**NOTICE OF EXHIBITION OF ENVIRONMENTAL IMPACT STATEMENT FOR THE
GREGORY PLACE BUILD TO RENT SCHEME (2A GREGORY PLACE, HARRIS PARK)**

I refer to the above application and the request to provide advice on the proponent's *Environmental Impact Statement*.

ATTACHMENT 1 – Detailed Comments

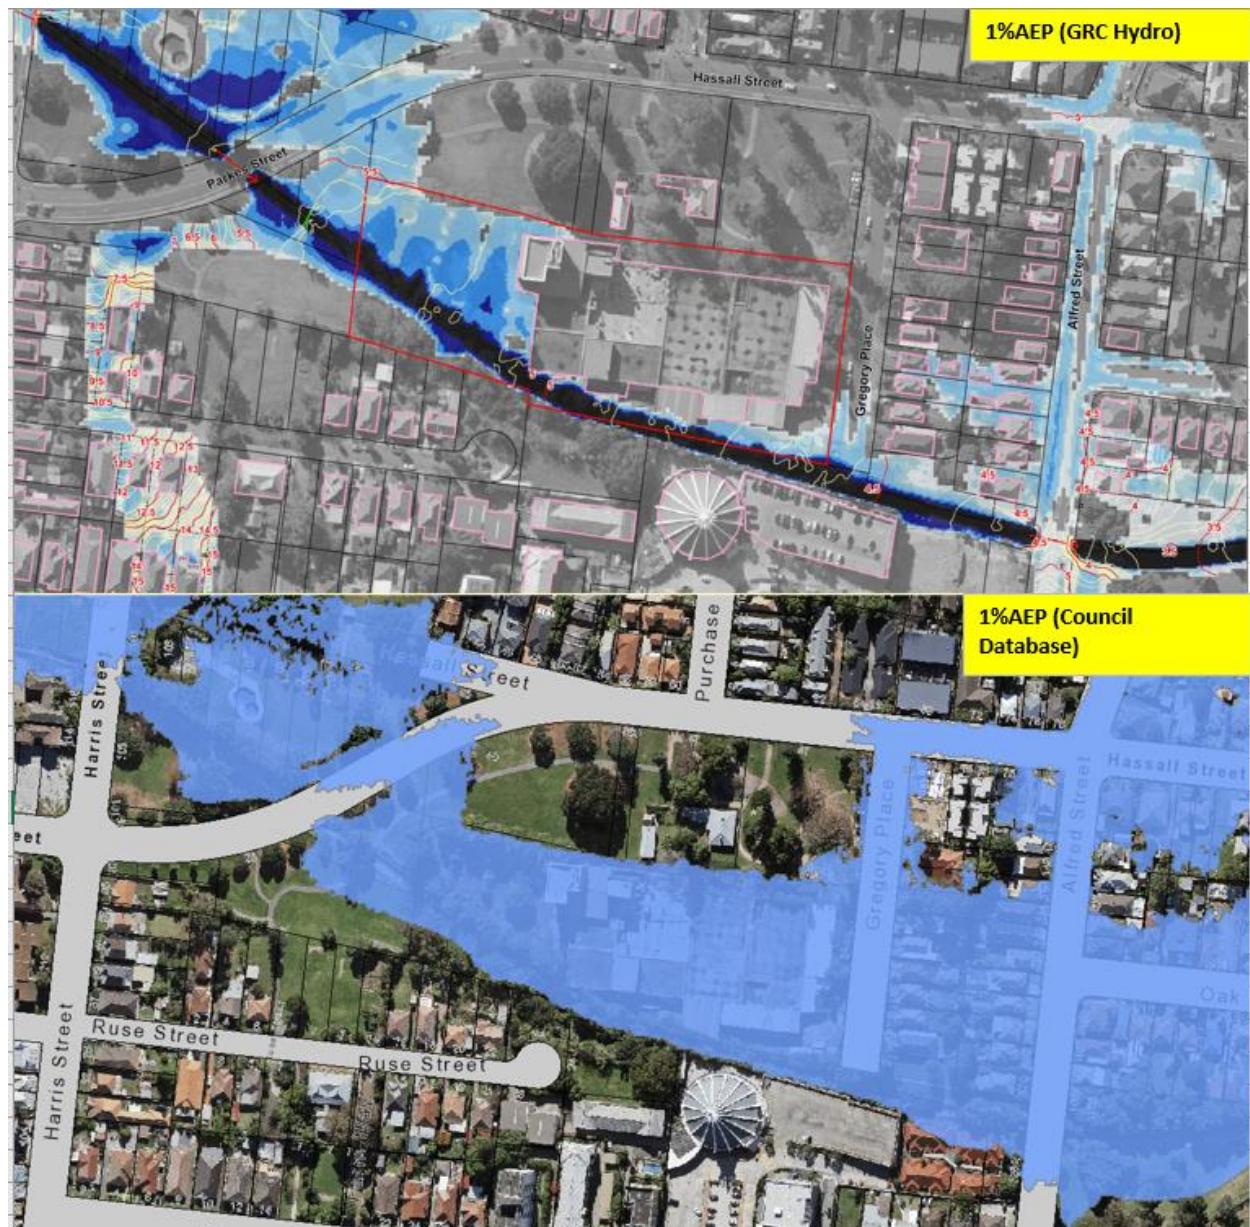
It is noted that creek bank along the subject site has been proposed to be engineered vertical wall as shown in the snapshot from landscape plans. Council does not support this type of bank treatment for natural creek.
